RE: Response to Comments: Planning Review Comments, Twin Milner SUP and CD Amendment 2023 at 20650 County Road 205, Routt, CO 80487

Planning & Environmental Health Review (Reviewed By: Alan Goldich and Scott Cowman)

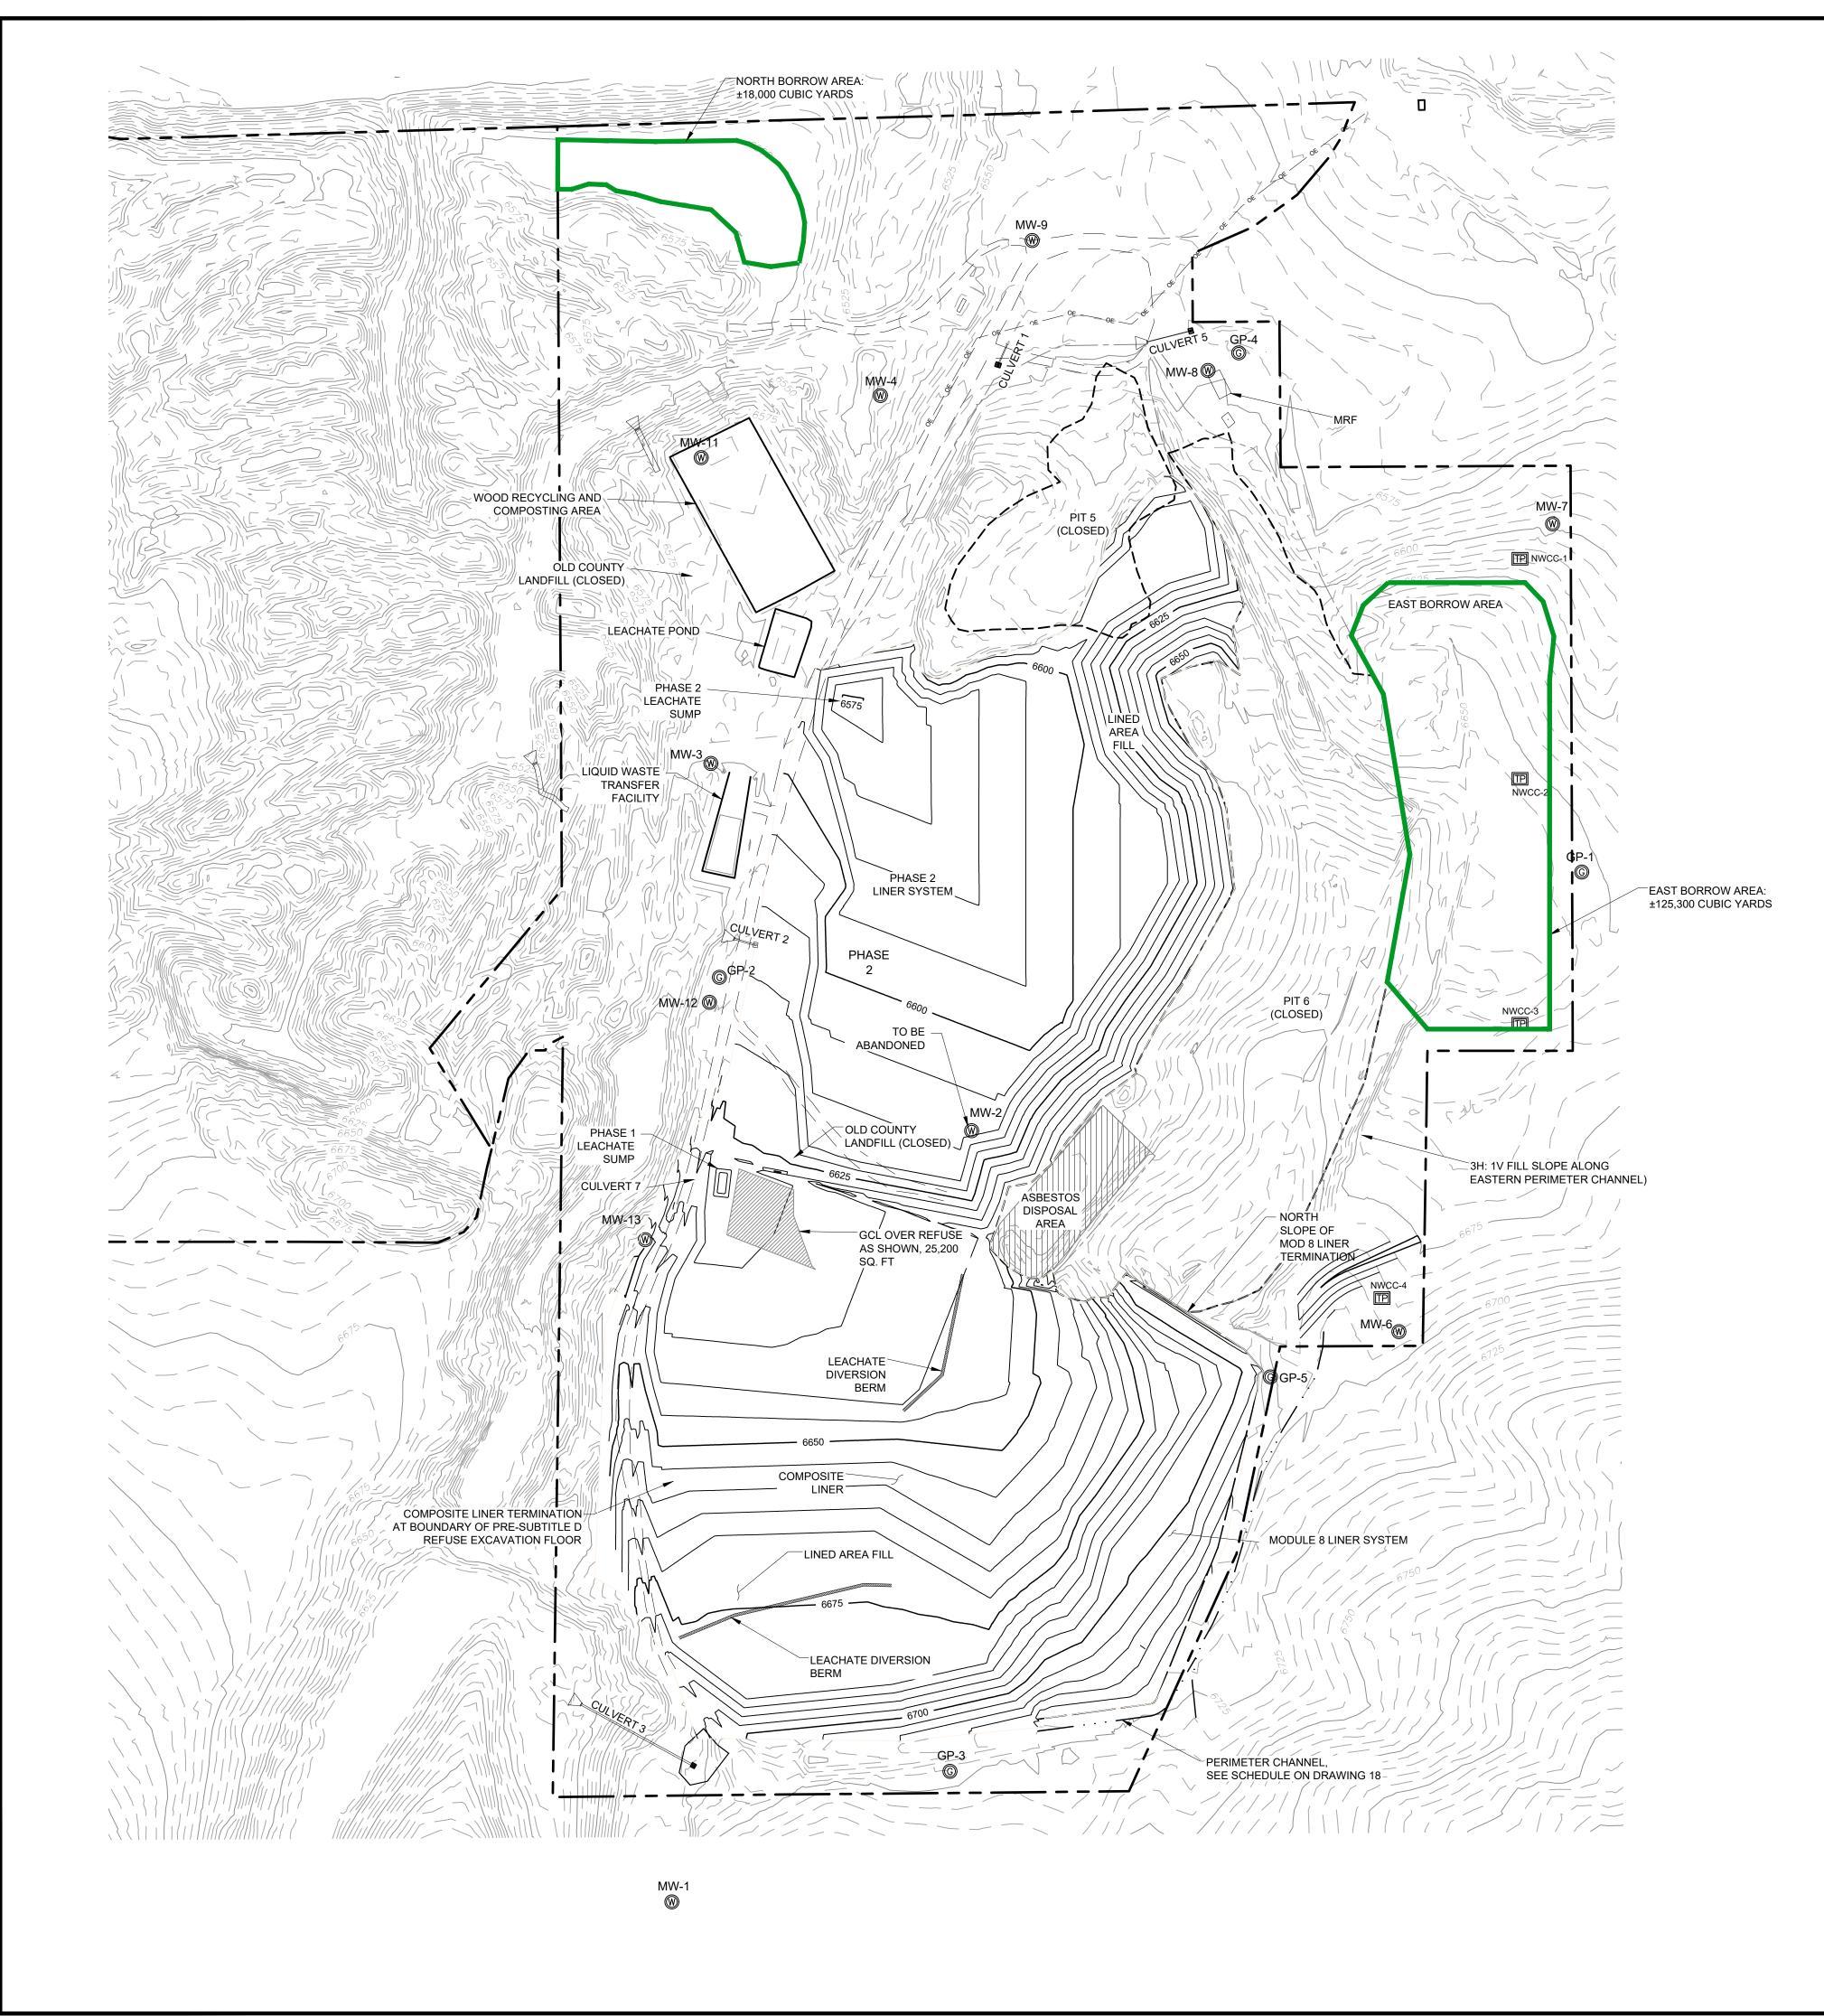
8. Please provide a timeline for when the different borrow areas will be developed to satisfy the soil needs for liner construction and ongoing operations. Please provide an estimate on the amount of soil and/or gravel that will need to be imported and a timeline for when that will occur. Also, there are conflicting references to the northern borrow area. Some references state that it is active and others say it is closed. Please clarify the status and use of the northern borrow area.

Mod 8 is the next phase of work that will require mining of the onsite borrow area(s). Twin has previously completed extensive borrow area studies onsite of the east and north borrow areas as well as the current borrow area just south of the Horseshoe (Doug's Drainage). It is Twin's intent to borrow clay from onsite sources for construction of the Mod 8 liner system. The attached Figure provides approximate clay soil availability from the East and North borrow areas. Calculations of available clay are based off of Golder's borrow studies and test pits completed by NWCC. There should be no additional truck traffic to the landfill for the clay material.
